YOUR REF: A/NE-FTA/275

**Temporary Warehouse (Excluding Dangerous Goods Godown) and  
Associated Filling of Land for a Period of 3 Years at various Lots in D.D.  
87 and Adjoining Government Land, Kong Nga Po, Sheung Shui**

We would like to respond to TD comments.

<p>項目:          丈量約份第 87 約地段第 339 號 A 分段、339 號 B 分段、339 號 C 分段、339 號餘段毗鄰政府土地擬議臨時貨倉 ( 危險品倉庫除外 ) 及相關填土工程(為期三年)</p>	<p>圖目:          交通行車線分析圖(入車)</p>
<p>圖號: 5</p>	<p>備注:</p>

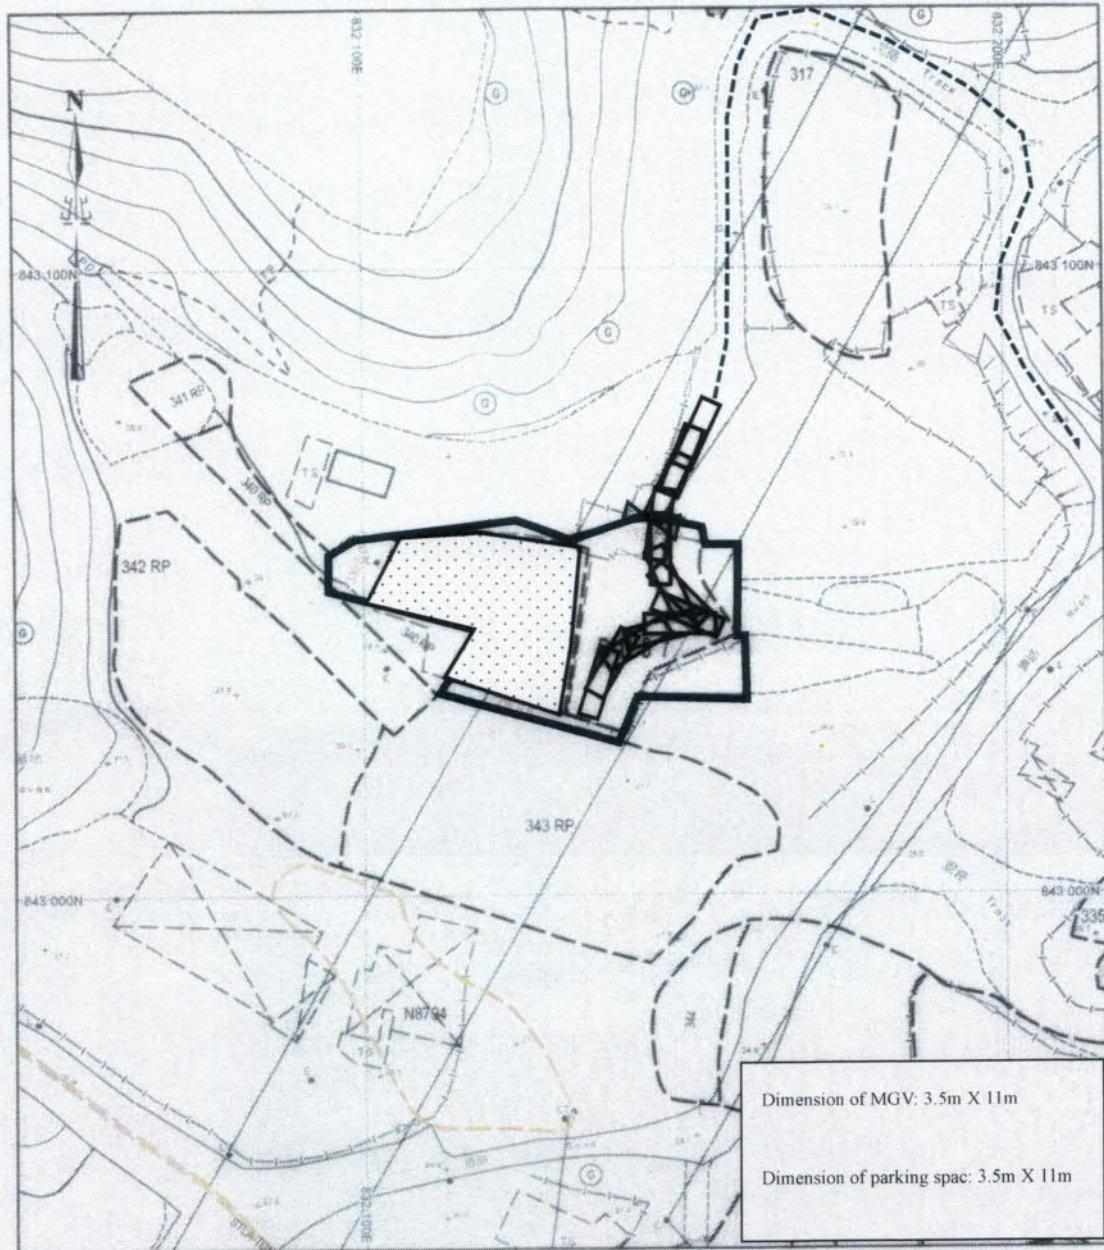
1) The applicant shall demonstrate the proposed vehicular access between Kong Nga Po Road and the subject site is sufficient for goods vehicles, preferably using the swept path analysis	Please find below diagram <b>5&amp;6</b> .
2) The proposed vehicular access between Kong Nga Po Road and the application site is not managed by Transport Department. The applicant should seek comments from the responsible parties.	Noted.

3. The operator will widen the vehicular access and the gate at least 7.3m
4. A warn Traffic Sign (TS no.460) is proposed to be placed at the entrance of the site.
5. A staff will be deployed at site to direct the vehicles in and out.
6. The gate will be keep opening at working hours, therefore there will be no vehicles is queuing.
7. Figure 5 and 6 is to demonstrated the ingressing and departing of the vehicles.
